Attachment 1 to SAP-18-34, "Supplemental 30 Day Responses to Nuclear Regulatory Commission Request for Additional Information Regarding Wolf Creek Generating Station Transition to Westinghouse Safety Analysis and Alternate Source Term Methodologies"
Non-Proprietary

**Supplemental 30 Day Responses to Nuclear Regulatory Commission
Request for Additional Information Regarding Wolf Creek Generating
Station Transition to Westinghouse Safety Analysis and Alternate
Source Term Methodologies [Non-Proprietary]**

RAI ARCB1-FHA-2 - FHA

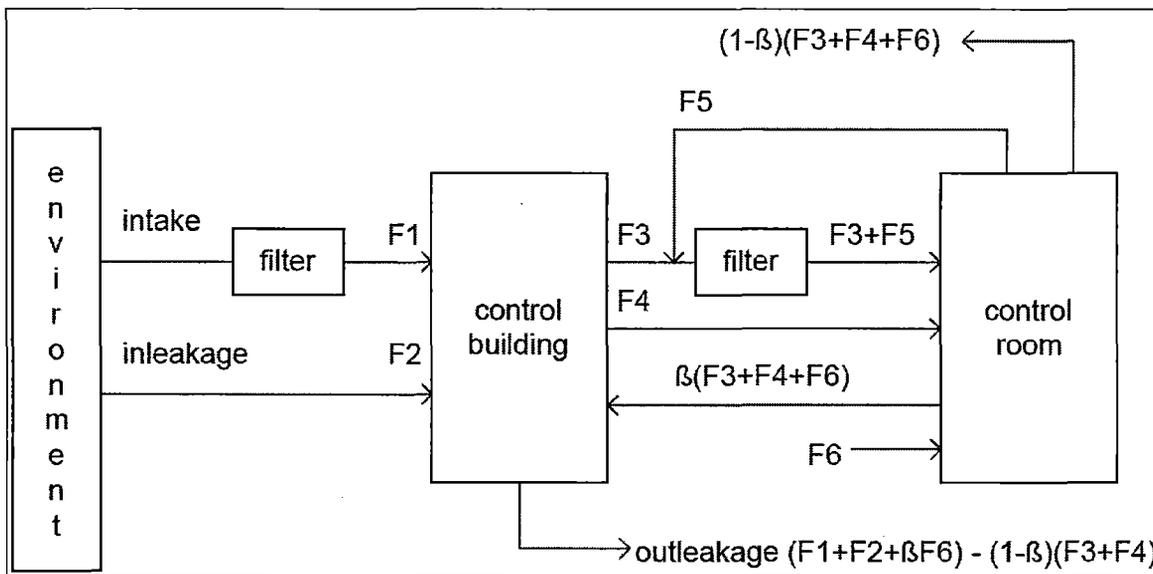
The reactor trip is assumed to occur 52 seconds after the SGTR. Assuming the loss of offsite power coincident with the reactor trip would allow credit for the condenser before the loss of offsite power. The assumption does not seem to be selected with the objective of maximizing the postulated radiological consequences, and the release of fission products from the secondary would not be coincident with the loss of power.

1. Please justify how the SGTR conforms to these regulatory positions or revise the analysis to be consistent with them.

As a result of the audit conducted on March 19 and 20, 2018 at the Westinghouse Rockville, MD office, additional discussion is provided for the SGTR scenario when considering a loss of offsite power at the start of the event; the additional discussion is related to the modeling of the control room, and includes a summary of the control room modeling assumptions. For completeness, the other events are also included in the summary of control room modeling assumptions.

The control room isolation is modeled in the dose analyses in two parts: actuation of the emergency mode filtration (in both the control building and the control room) and closure of the normal HVAC intake damper. The actuation of the emergency mode filtration occurs following receipt of an isolation signal (e.g. high radiation or safety injection). Closure of the normal HVAC intake damper occurs on a safety injection signal or manual action. Prior to closure of the normal HVAC intake damper, the unfiltered inleakage is modeled with a X/Q consistent with the normal mode HVAC intake; after this occurrence, the unfiltered inleakage is modeled with a X/Q consistent with the emergency mode HVAC intake. In the analyses, a failure of one of the filtration fans is assumed at the start of emergency mode resulting in a larger unfiltered inflow to the control room (since only half of the makeup flow to the control room passes through a filter). After a defined time of 90 minutes from the start of the event, operator action isolates the failed train and terminates the unfiltered inflow to the control room, and consequently lowers the filtered inflow to the control building.

Following the SGTR, the releases of noble gases results in an immediate high radiation signal; noble gases have a condenser DF of 1 and so are not affected by loss of offsite power timing. Emergency mode filtration would be actuated following a 60-second delay to account for instrumentation delays and damper movement. The SGTR dose analysis arbitrarily and conservatively models emergency mode filtration as being actuated at 120 seconds.

The safety injection signal is generated at 325 sec after event initiation and normal HVAC intake damper closure would occur at 385 sec after event initiation (including a 60 second delay for instrumentation delays and damper movement). The SGTR analysis conservatively models normal HVAC intake damper closure at 10 minutes (600 seconds) after event initiation.

With respect to the SGTR, a loss of offsite power at the start of the event would not significantly affect the plant response, only the timing. The major dose contributors, such as post-trip flashed break flow, total break flow and post-trip ruptured SG releases are driven by decay heat removal and so would be unaffected. Essentially, the sequence of events with respect to the releases would shift by approximately

52 seconds (0.014 hours); these 52 seconds are also within the conservatism added to the start of emergency mode filtration and normal HVAC intake damper closure. Removing the first 52 seconds of releases from the model and removing added conservatism to the control room emergency mode actuation and normal HVAC intake damper closure would result in a slight decrease in calculated dose.
